**Subject: Data Response #1 through #9, Air Quality Amendment 1
Ivanpah Solar Electric Generation System 07-AFC-5C**

Air Amendment 1, Ivanpah Solar Electric Generating System

Responses to Data Request #1 through 9 Received from

Christopher Dennis, CEC, Sacramento, CA

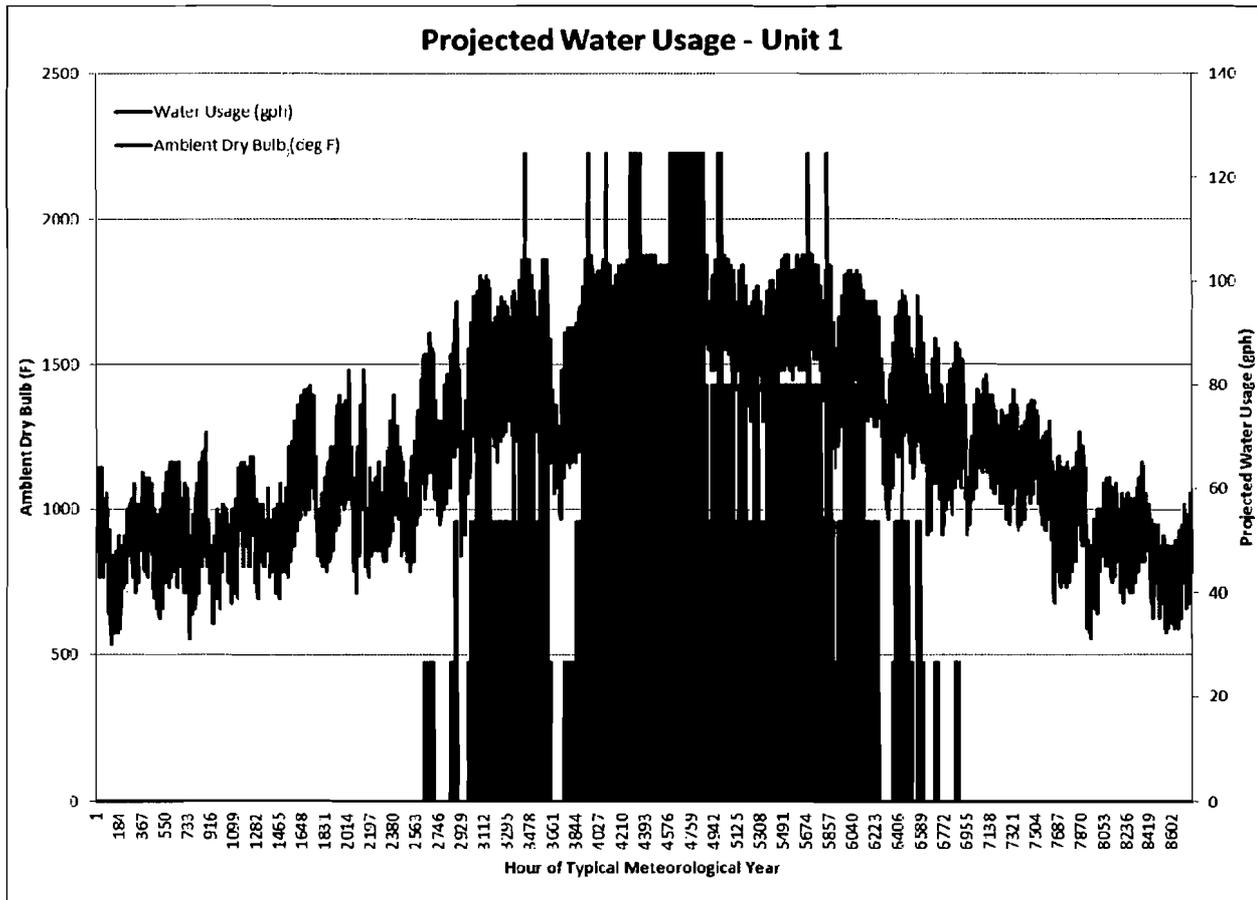
8. Please quantify the hours of annual operation of when the WetSAC system will use water, the water use rates, and the threshold for wet cooling (i.e., water use at 82°F, 86°F, or some other trigger or process threshold).

Hourly TMY ambient temperatures for Las Vegas (ID #114853575) were plotted against the projected makeup water to the WSAC for hours where the Global Horizontal Irradiance (GHI) is greater than zero (sun is shining). The following scenarios were considered:

For example, if the GHI is greater than zero, the unit will be operating, but if the ambient dry bulb temperature is less than 86°F, there is no makeup water to the WSAC, as it would be in either bypass or dry cooling mode. Alternatively, if the GHI is greater than zero, but the ambient dry bulb temperature is greater than 105 °F, only the wet cooling system would be running and the makeup water to the WSAC would be approximately 2,226 gph as shown in the Attachment 2, page 8, table B. If the GHI is zero, there is no makeup flow to the WSAC, as the unit will not be operational at that time (night).

Based on this information, it is anticipated the WSAC would operate for approximately 1,700 hours per year. The exact hours of operation will be highly dependent on the weather.

PIPING & INSTRUMENT DIAGRAM
 CLOSED COOLING WATER SYSTEM

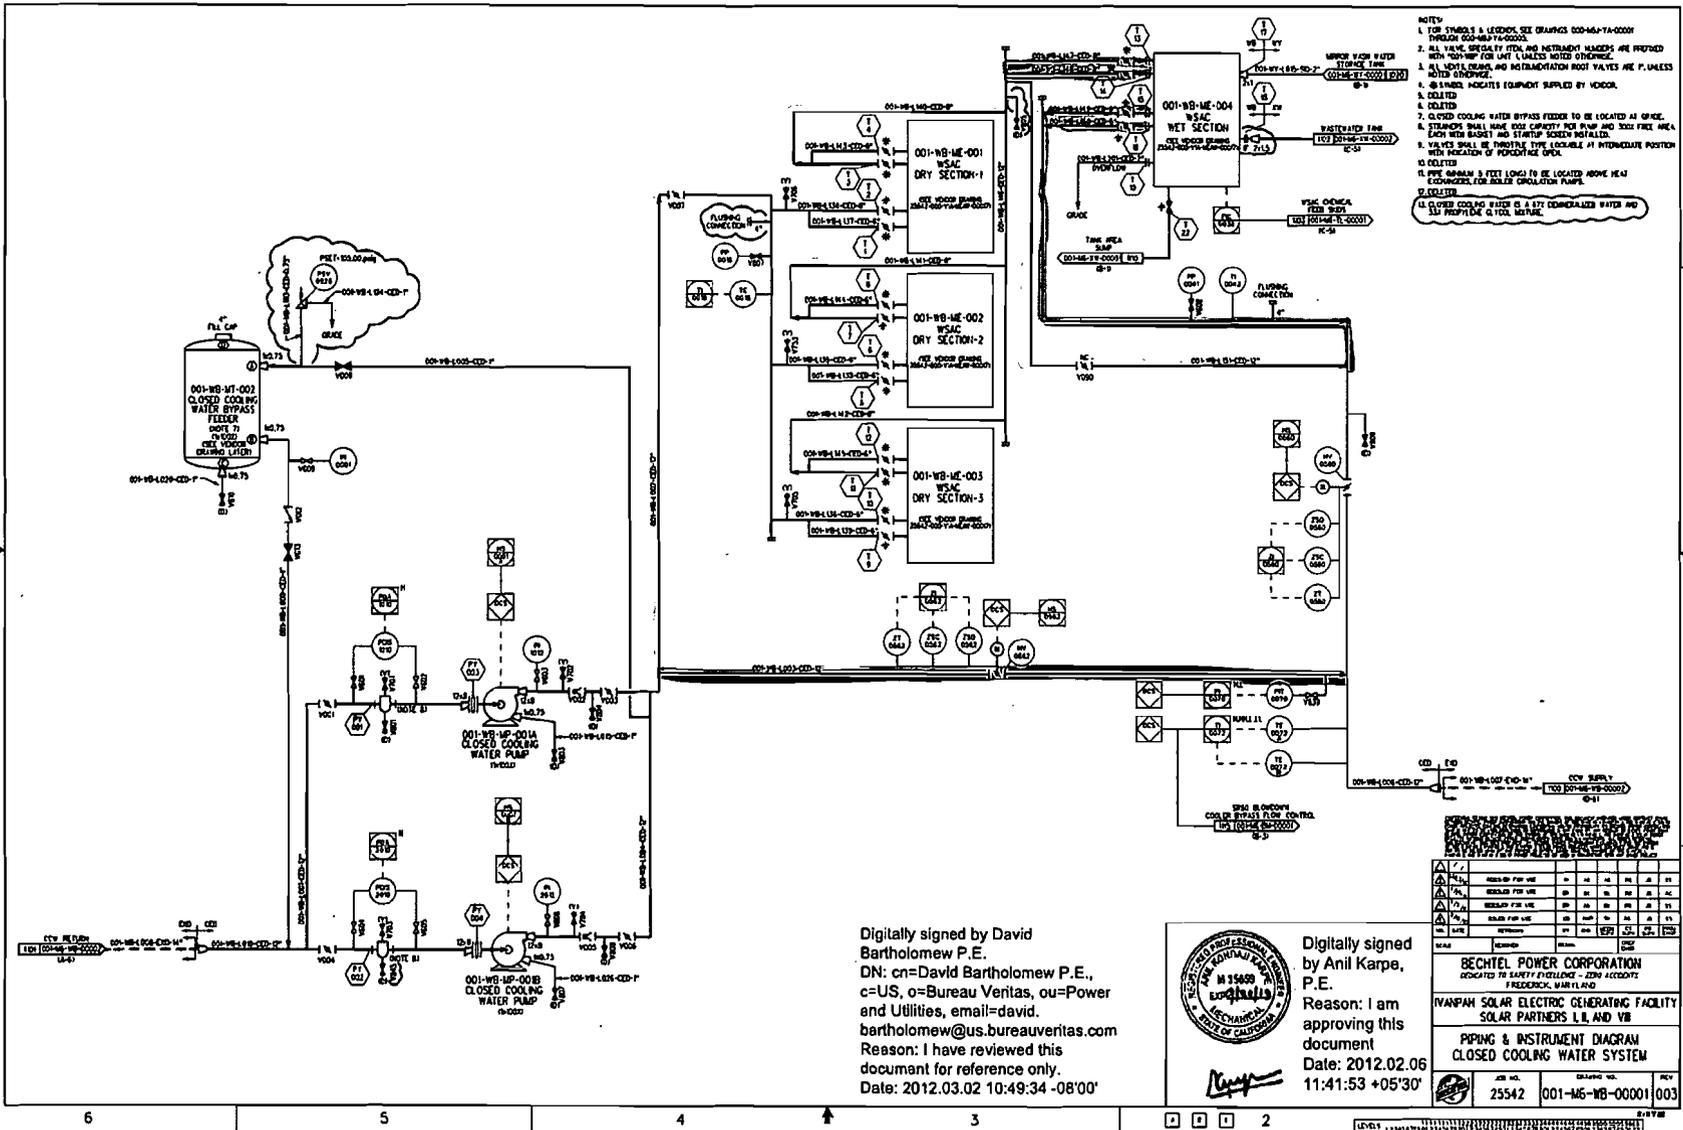
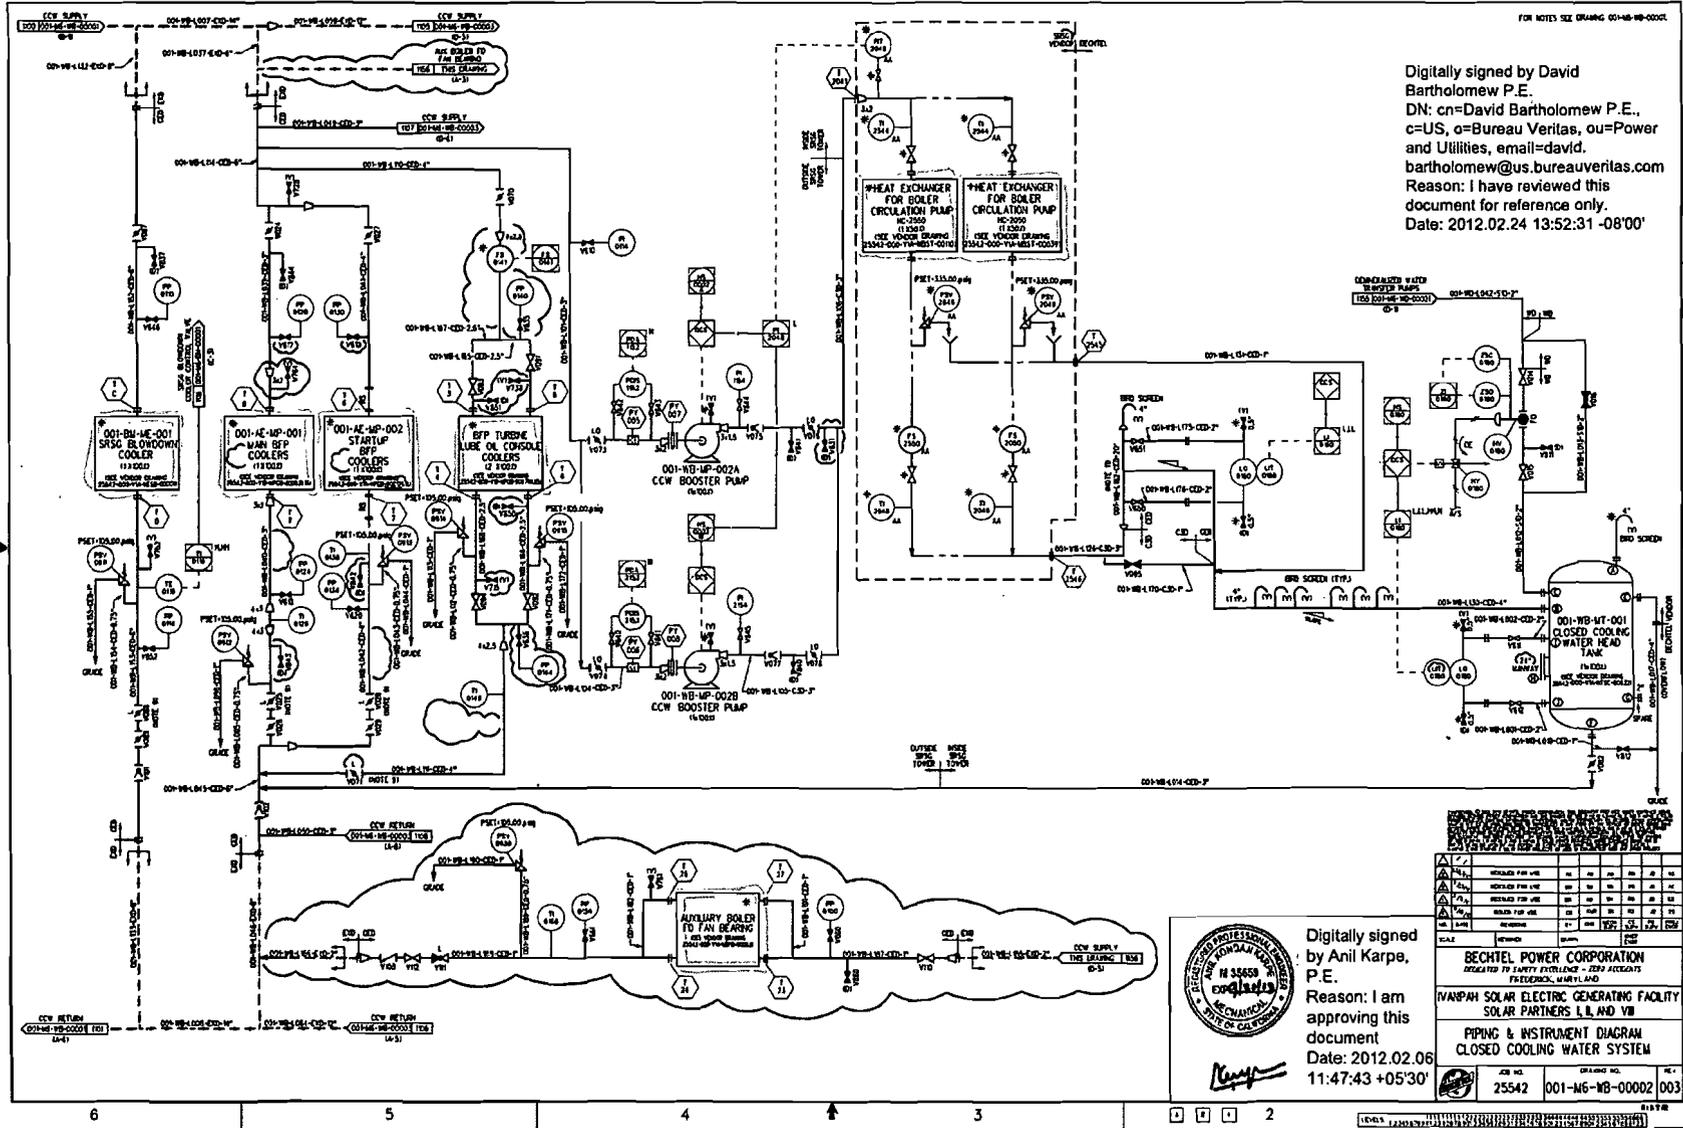
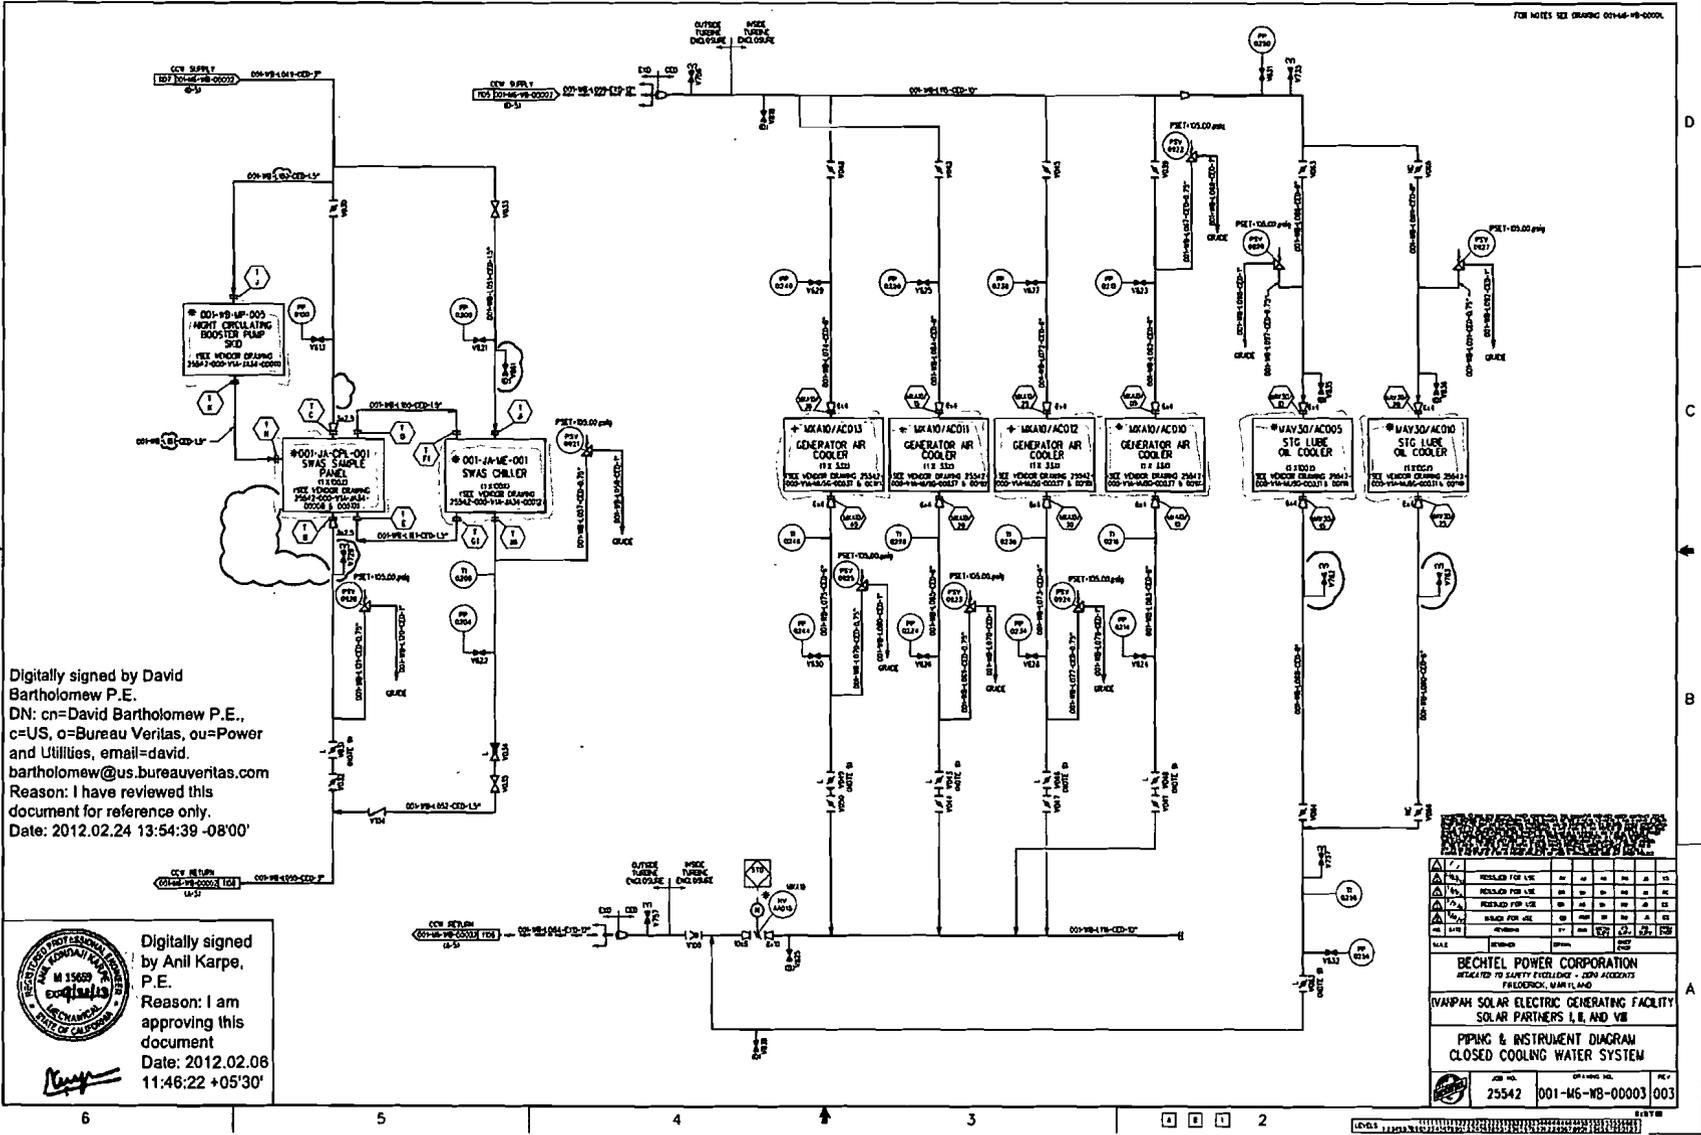
6. Please provide a detailed description of how the proposed WetSAC will be incorporated with the water conveyance, water treatment, and wastewater discharge facilities.

The Wet Surface Air Condenser (WSAC) is part of the Closed Cooling Water (CCW) system. The primary function of this system is to provide cooling water to the main boiler feed pump lube oil and seal oil coolers, the steam turbine generator lube oil coolers, generator air coolers, solar receiver steam generator (SRSG) blowdown coolers, auxiliary boiler forced draft (FD) fan bearing coolers, boiler circulation pump heat exchangers, and sample panel coolers. As the CCW picks up heat from the various sources listed above, the hot water is pumped to the heat exchanger where heat is transferred from the CCW using either the dry section or the wet section (depending on ambient conditions and CCW system temperatures). Lower temperature CCW is then returned to the end users listed above to repeat the cycle. Refer to the P&ID in Attachment 1 (Bechtel drawing 25542-001-M6-WB-00001, rev 003).

Above 86°F ambient temperature (dry bulb), dry sections of the WSAC cannot take the full load and the wet section is started. Up to 105°F ambient temperature, dry and wet units operate together to provide cooling. Above 105°F ambient temperature, the dry sections can no longer provide the necessary cooling, and the wet section will take the full cooling load.

Stream 32 in the attached P&ID shows the demineralized makeup water to the WSAC. Cases 1 through 30 do not reflect any demineralized water makeup to the WSAC. This is due to the fact that the ambient temperatures for these cases fall below the 86°F ambient threshold. Beginning with case 31 and continuing through case 54, both the wet and dry portions would be in use. From case 55 through 72, only the wet portion would be in use as the ambient temperature exceeds 105°F.
